**CBE, Sierra Club, Center, ForestEthics et al. Comments on the Revised Draft
Environmental Impact Report for the Phillips 66 Company Rail Spur Extension and Crude
Unloading Project**

**Attachments to Expert Report of Phyllis Fox on the Revised Draft Environmental Impact
Report for the Phillips 66 Rail Spur Extension and Crude Unloading Project, November
2014.**

Comments
on
Environmental Impact Report
for the
Phillips 66 Propane Recovery Project

Rodeo, California

Phillips 66 Propane Recovery Project - 120546
Figure 3-4
Overall Block Flow Diagram of Refinery

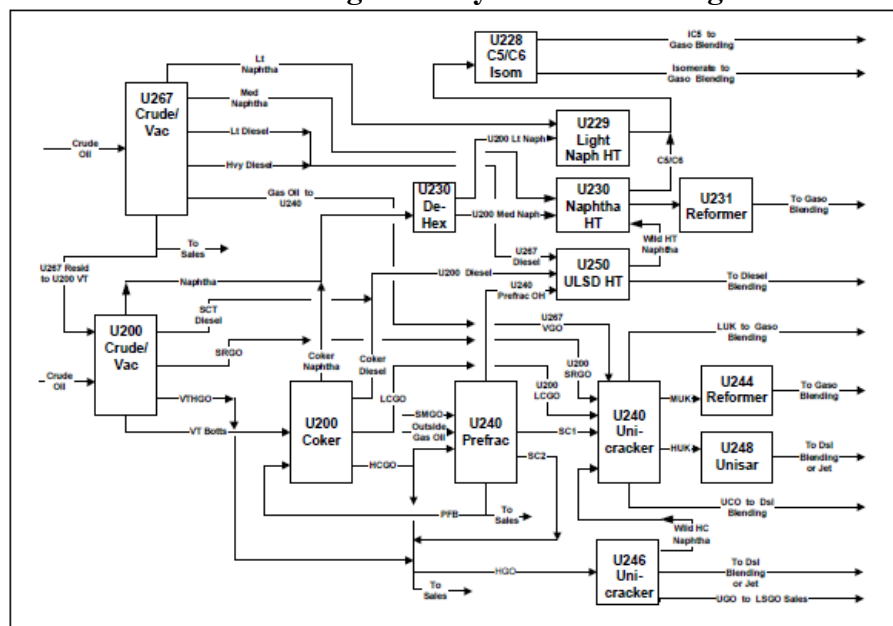
This link is clearly shown in the Rodeo Refinery block flow diagrams in the subject Rodeo Refinery DEIR. The block flow diagram for the existing Rodeo Refinery, DEIR Figure 3-4, shows "SMGO" entering the Refinery at the U-240 Prefractionator unit (Prefrac unit). DEIR, p. 3-12 ("Heavy gas oil (HGO) streams from Unit 200 and HGO purchased from outside of the Refinery are fractionated in the Unit 240 prefractionator."). SMGO is Santa Maria Gas Oil. This DEIR figure is reproduced here as Figure 1 for ease of reference. The U-240 Prefrac unit separates Santa Maria gas oil and other gas oils into lighter hydrocarbon fractions that are currently blended into the Refinery Fuel Gas, shown in Figure 3-5 (see lower left hand corner, blue arrow labeled U-240/244/248 S-RFG being routed to U-240 Fuel Gas Treating), but which will be further processed into propane and butane in new units added to the Rodeo Refinery as part of the Project.

Under the Project, the output from the Prefrac unit is sent to the proposed "RFG Propane Recovery Unit" instead of the Refinery Fuel Gas system. This unit is the heart of the subject Project and is immediately adjacent to the Unit 240 Prefrac unit. DEIR, Table

Phillips 66 Propane Recovery Project, 120546
Figure 3-6
Proposed Refinery Fuel Gas System Block Flow Diagram

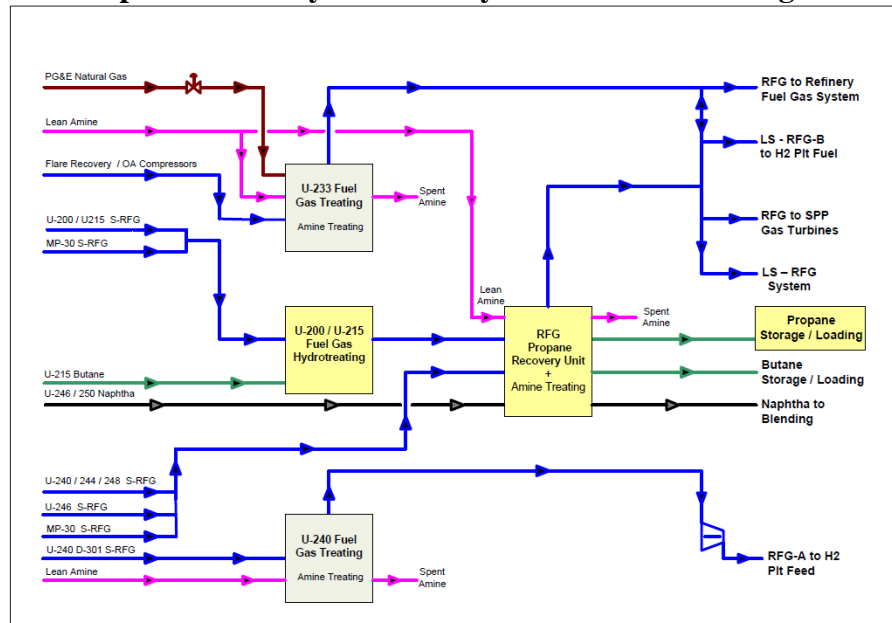
3-2. Propane and butane are recovered in this unit. This new propane/butane extraction unit is shown in DEIR Figure 3-6, which is reproduced here as Figure 2 for ease of reference.

The RFG Propane Recovery Unit is the big yellow box in the middle of Figure 2. Blue arrows in the lower left hand corner of Figure 2 identify the inputs to this unit, which are various refinery streams. These streams include "U-240/244/248 S-RFG." This designation means that Refinery Fuel Gas (RFG) from Unit U-240 is sent to the RFG Propane Recovery Unit. (This stream was formerly sent to the U-240 Fuel Gas Treating Unit. DEIR, Fig. 3-5.) As Santa Maria Gas Oil (SMGO) is one of the inputs to Unit U-240, changes at the Santa Maria Facility would be transmitted directly to the Project via the U-240 Prefrac Unit.

This establishes a direct link between this Project and modifications at the Santa Maria Facility. This is the "nexus" to the larger project with the potential to change crude oil feedstocks.
